HISTORIC AND DESIGN REVIEW COMMISSION

February 15, 2023

HDRC CASE NO: 2022-189
ADDRESS: 922 HAYS ST
LEGAL DESCRIPTION: NCB 1657 BLK E LOT E 16.2 FT OF 5 & W 33.8 FT OF 6
ZONING: R-5, H
CITY COUNCIL DIST.: 2
DISTRICT: Dignowity Hill Historic District
APPLICANT: Michael & Kelsey Shaffer
OWNER: Michael & Kelsey Shaffer
TYPE OF WORK: Installation of siding and Historic Tax Verification
APPLICATION RECEIVED: January 27, 2023
60-DAY REVIEW: Not applicable due to City Council Emergency Orders
CASE MANAGER: Rachel Rettaliata

Historic Rehabilitation Application: Michael & Kelsey Shaffer – 922 Hays St – Written Narrative

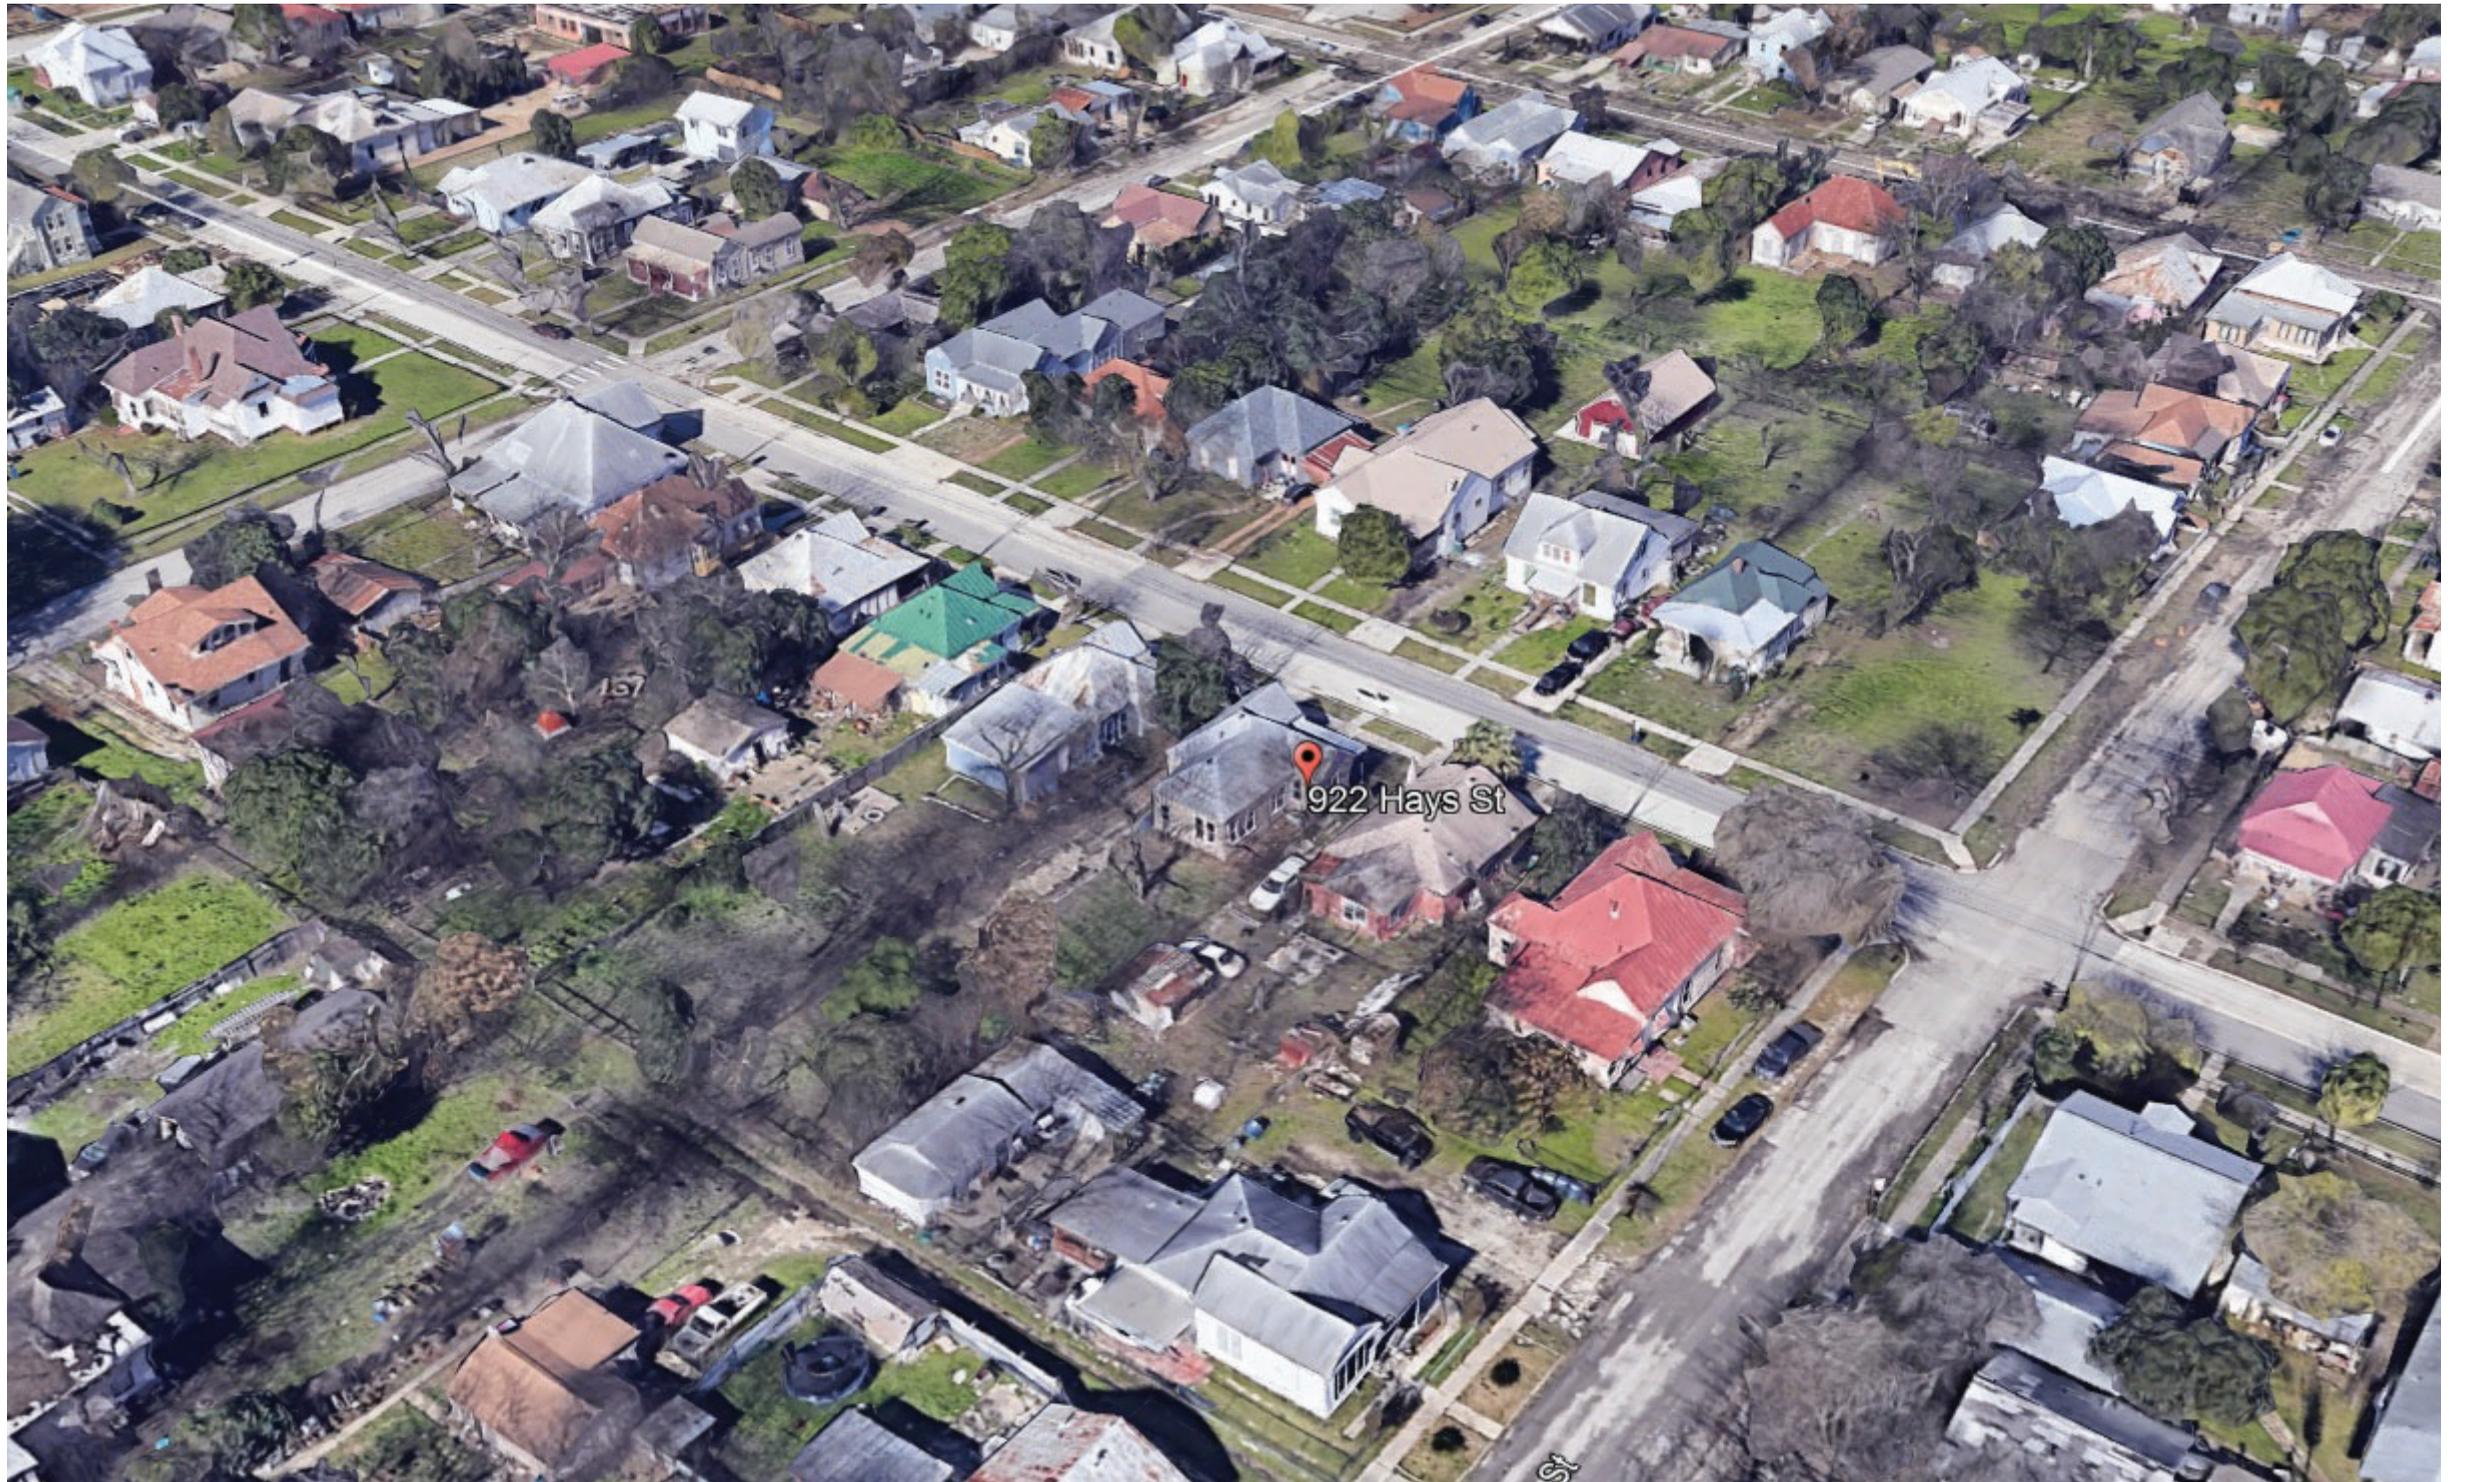
- c. COMPLIANCE – Staff conducted a site visit on March 29, 2022, to examine the conditions of the property. Staff observed that the new siding installed at the rear of the property featured a faux wood grain texture, which does not comply with the HDRC approval issued on April 17, 2019. The HDRC approval for Case No. 2019-182 included the stipulation that the rear addition feature siding with a smooth finish and an exposure of 4 inches. The property is not eligible for the Substantial Rehabilitation Tax Incentive until the property comes into compliance.

Item 1, staff does not recommend approval of the installation of faux wood grain composite siding on the rear addition. The applicant is required to install composite siding with a smooth finish and an exposure of 4 inches to comply with the HDRC stipulation for Case No. 2019-182.
